NSW Department of Planning and Environment

Date: 11th August 2025

Subject: Request for information – Mod 25/11574 (DA23/1635 Mod 1 – PAN – 555698) – Jindabyne Sport and Recreation – Modification 1

PROPOSED MODIFIED FOOTPRINT

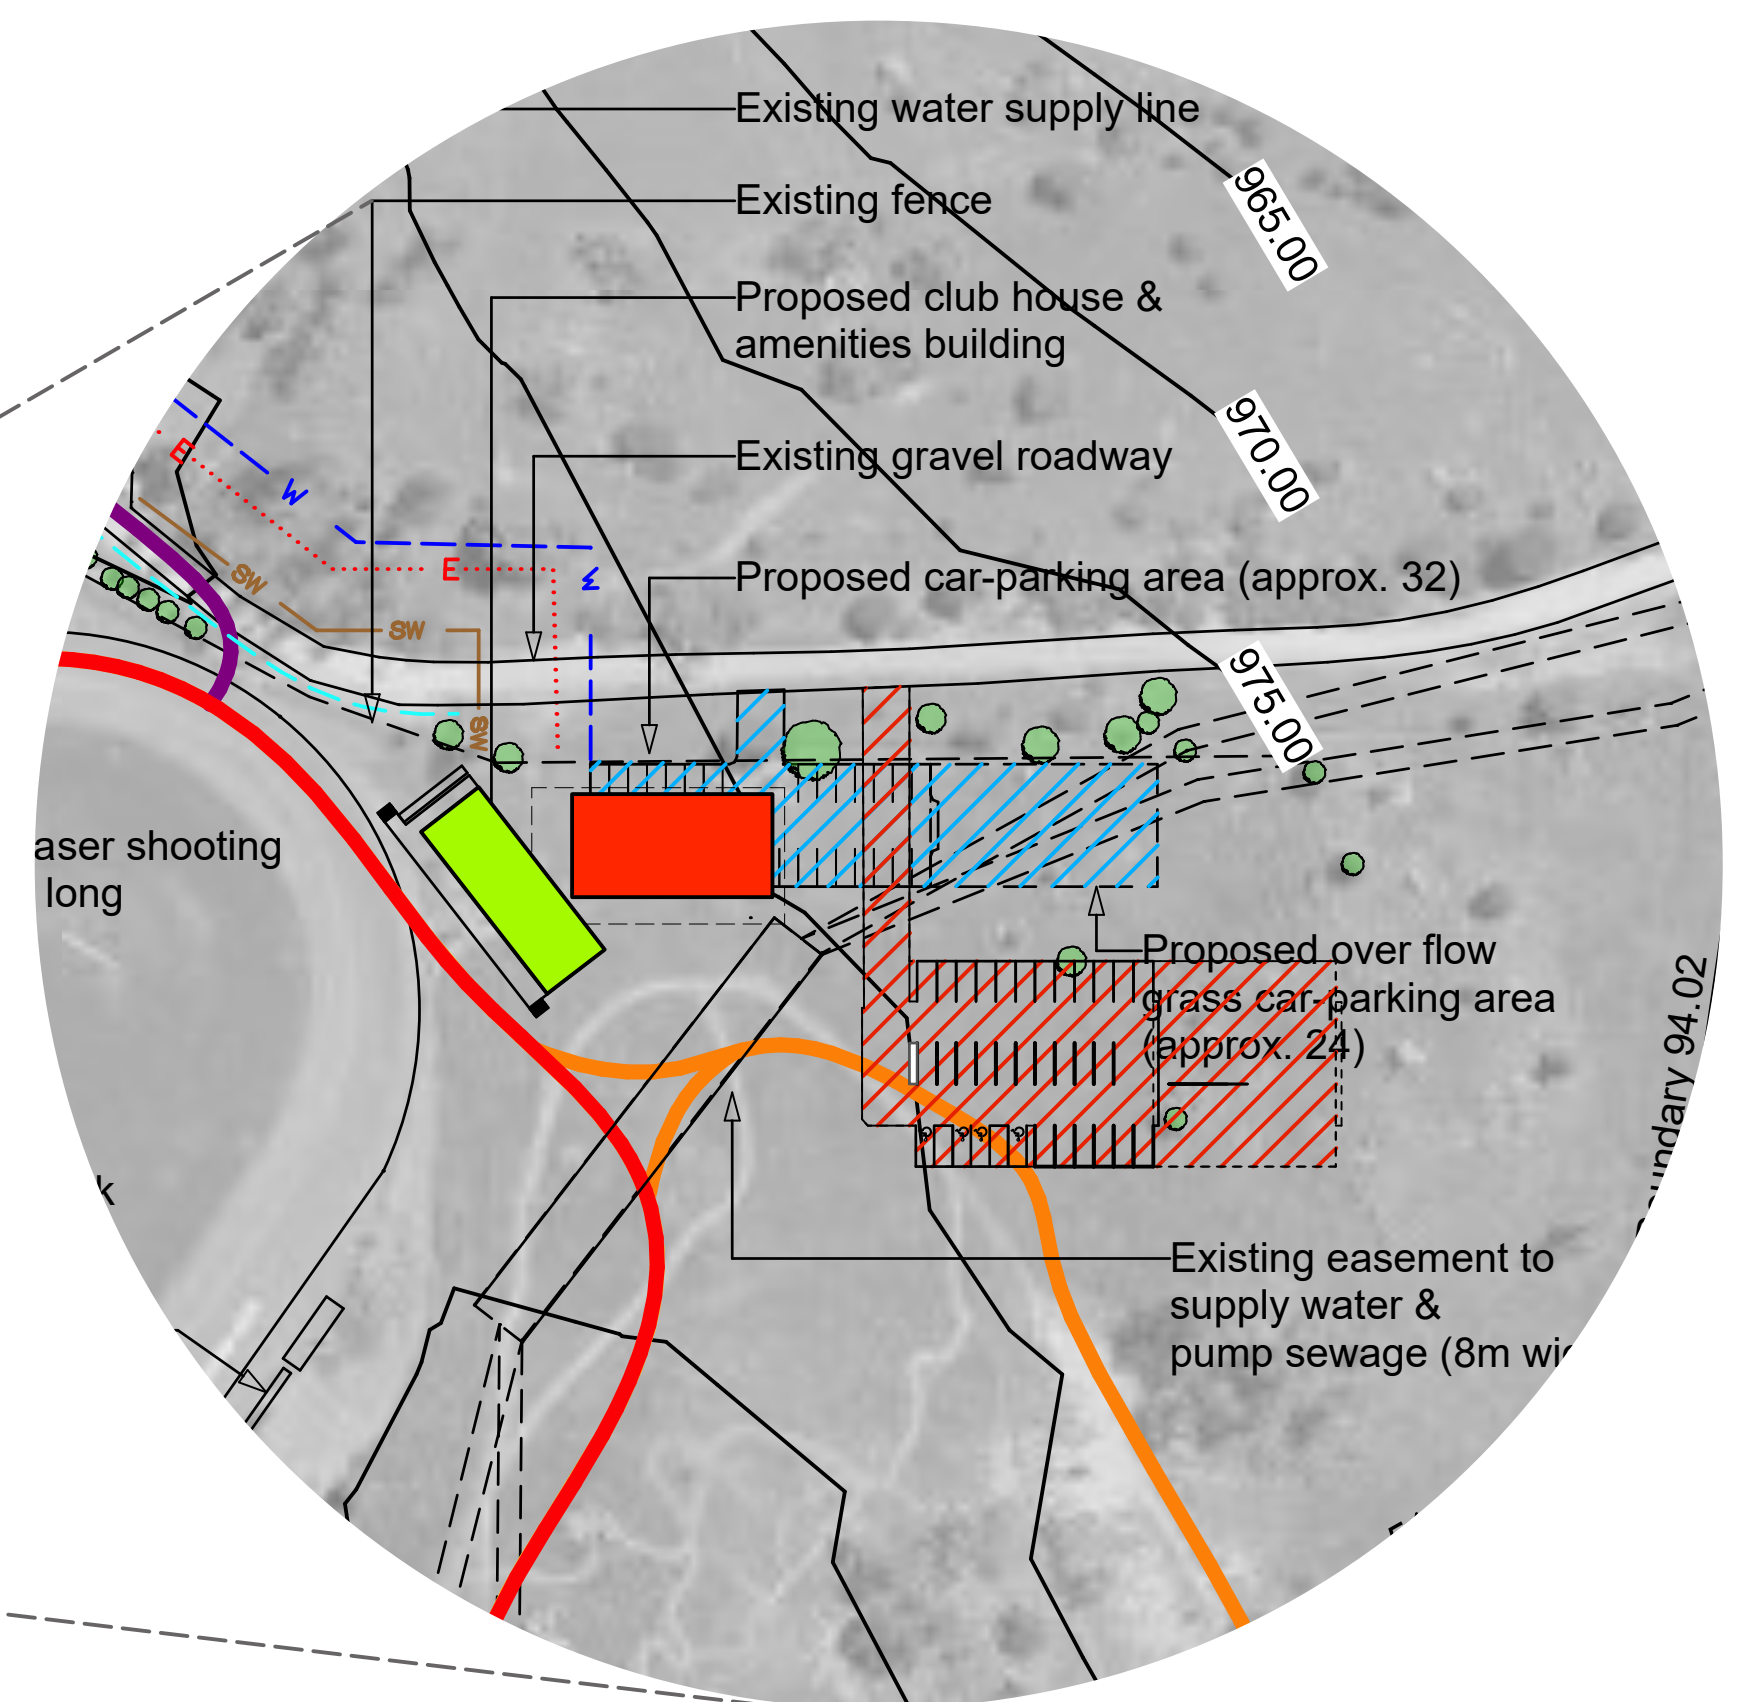
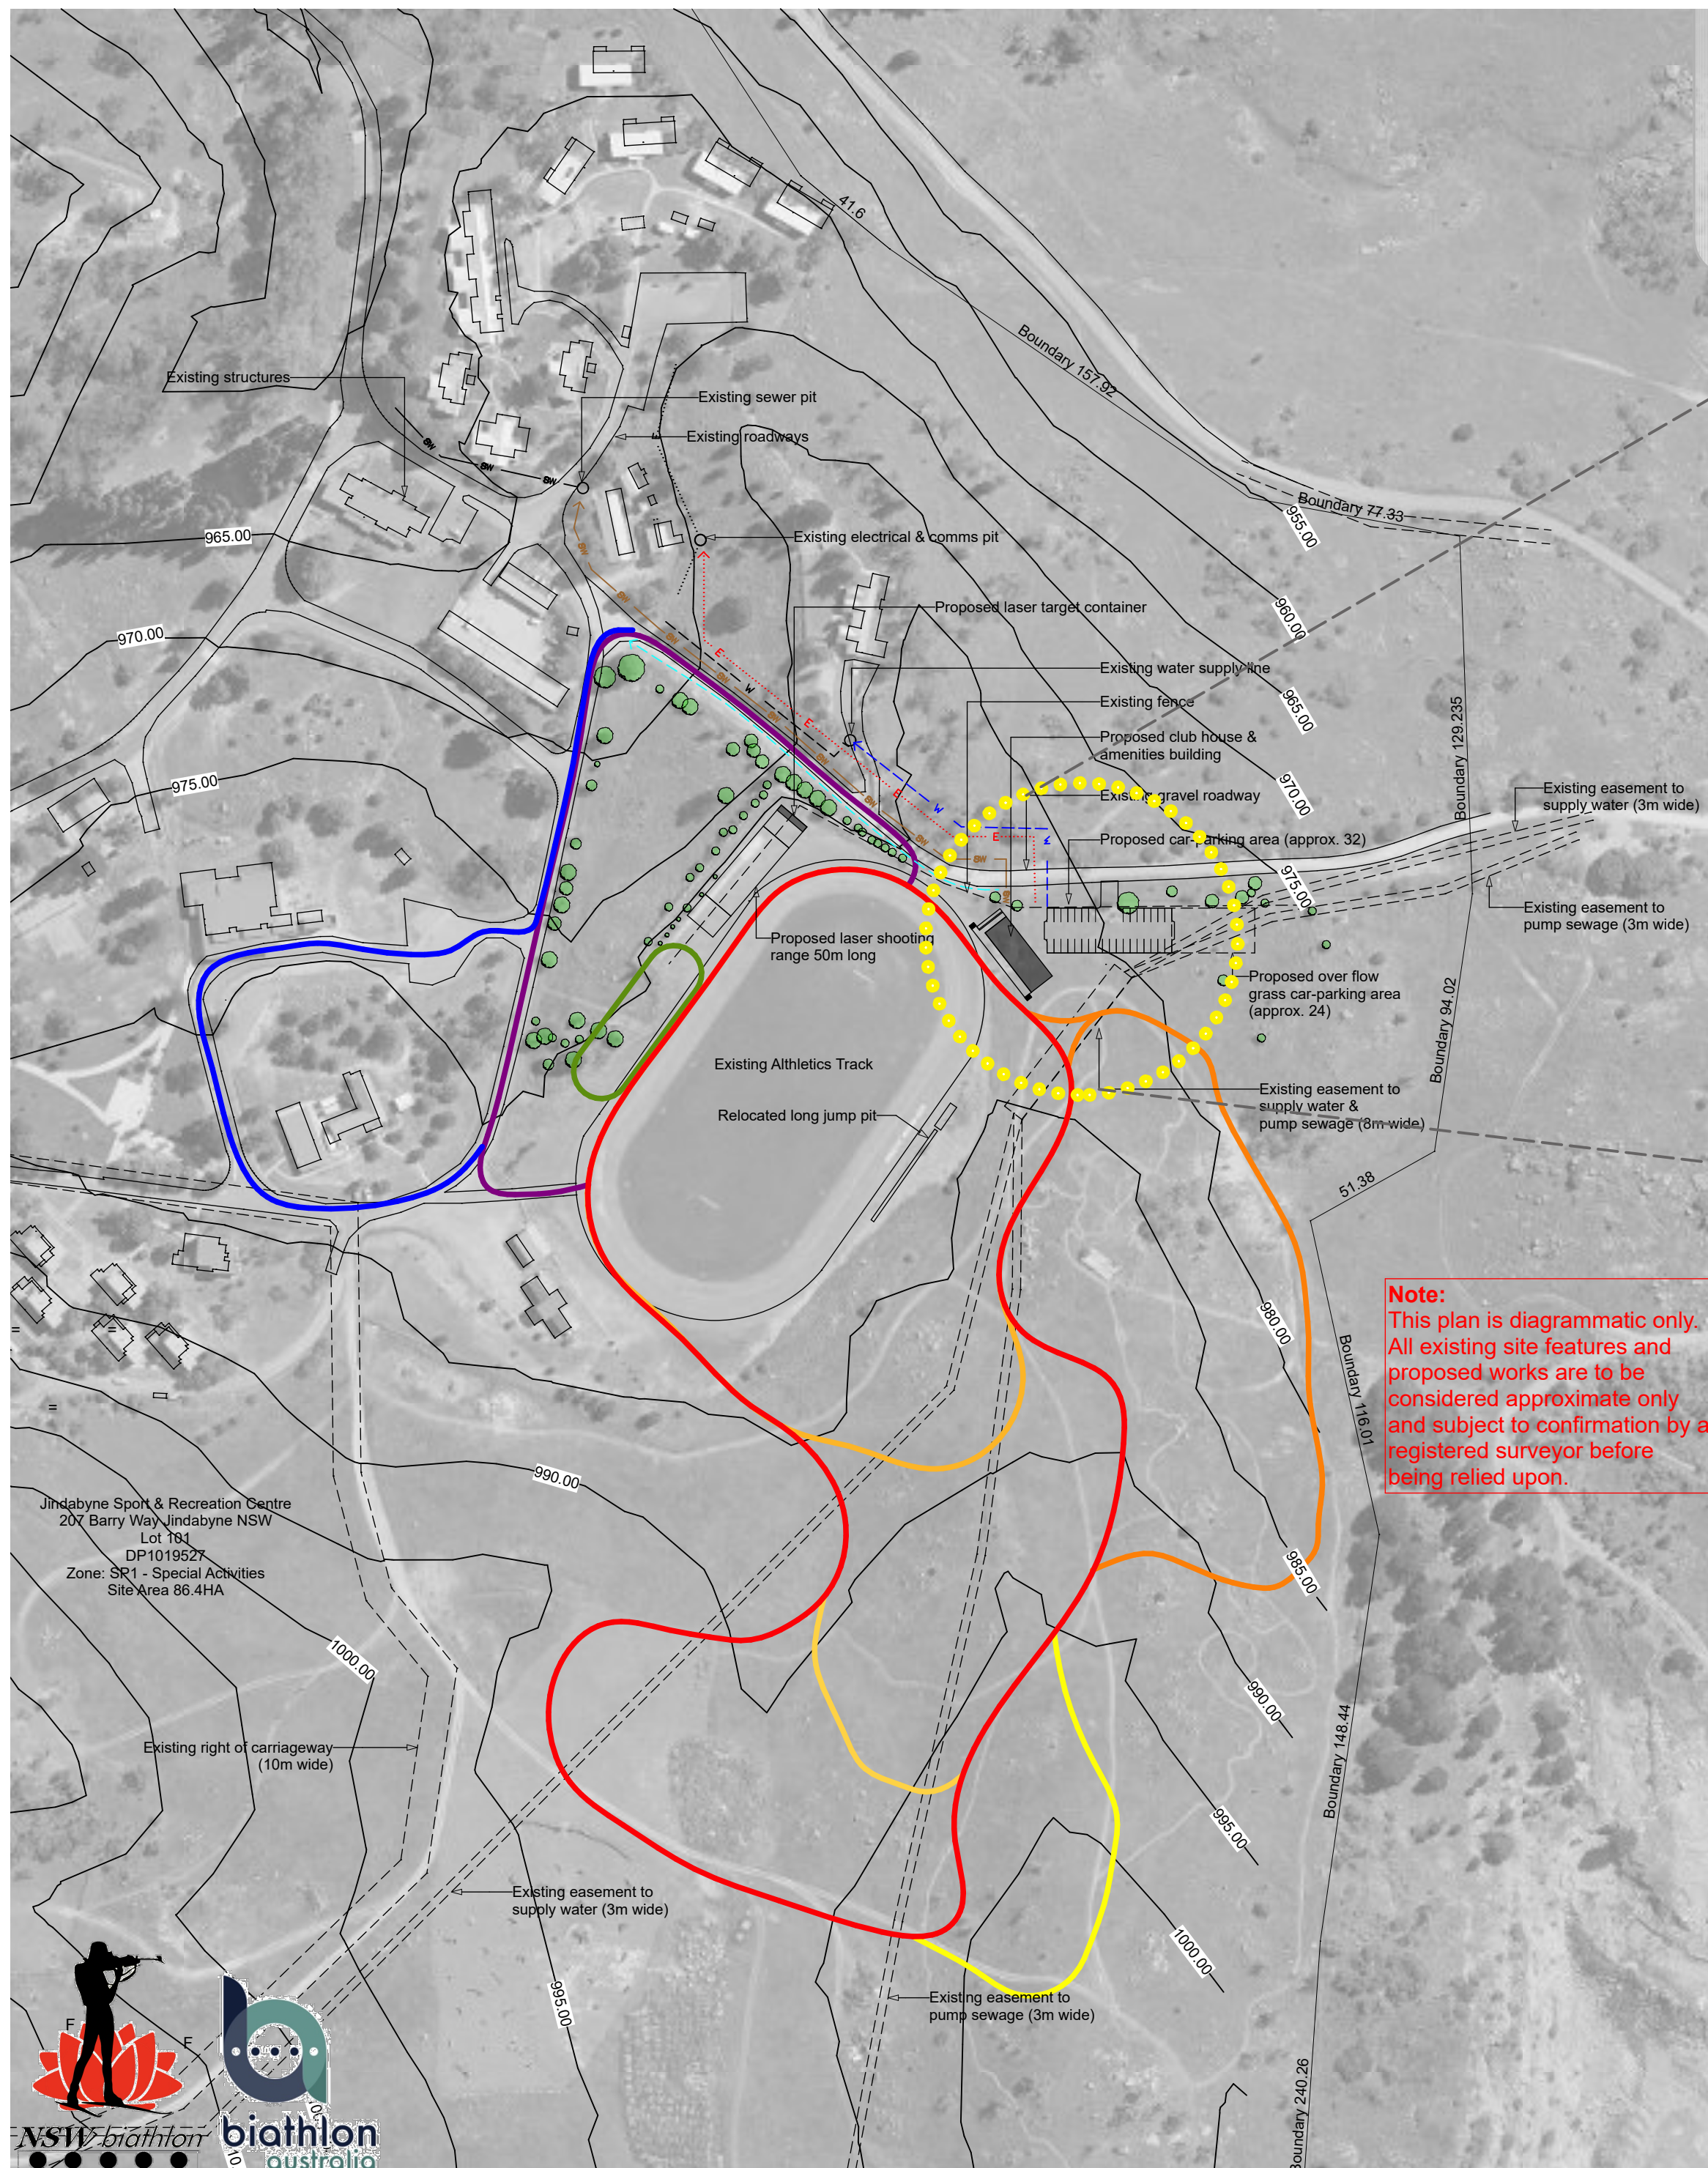
Plans that clearly show the footprint of the development as approved as compared to the proposed modified footprint, including to key site features and approved development (driveways, carparks etc)

The modification relates to the design and location of the amenities and administration/storage space building and parking only, which constitutes a small component of the overall approved facility. The wider development including the roller ski and cycleway tracks, upgrade of oval facilities including oval grassing, track resurfacing, lighting and establishment of laser biathlon facilities remain consistent with the approved development.

Throughout the detailed design phase it became evident that the amenities and administration/storage space building was positioned too close to the roller ski and cycleway track and did not provide sufficient circulation space. The modified plans provide sufficient separation and circulation space. Furthermore the approved plans detailed a prefabricated amenities and administration/storage building. Following the issue of the consent and throughout the detailed design phase the requirement to modify the prefabricated construction methodology became apparent. Due to the snow and wind loading requirements of the area the prefabricated building required extensive additional bracing that became cost prohibitive. The change of construction methodology also provided the opportunity to review the functionality of the spaces in consultation with local users (given the multi-sport nature of the grant) and in particular its accessibility for disabled athletes. The resulting amended design and layout has been developed in extensive consultation with the various user groups. The amended plans reflect a more considered design that meets the needs of its end users, it is designed for the local environment and the change from prefabricated to on-site construction will employ local businesses throughout the design and construction process.

The approved location of the carpark required excessive civil works to level the area. The modified plans have positioned the carpark in a naturally flat area of the site to minimise the civil works required to construct. It should be noted that the dirt access road is not a public road, it is a private dirt road within the Sport and Recreation precinct with a locked gate at the lot boundary. The modified carpark layout provides the same number of car spaces as the approved plans. There are no changes to traffic, access or otherwise.

Climb C on the approved plans was approved in concept only and is subject to a further development application. Climb C would require rerouting as part of a subsequent development application to avoid the proposed carpark location.
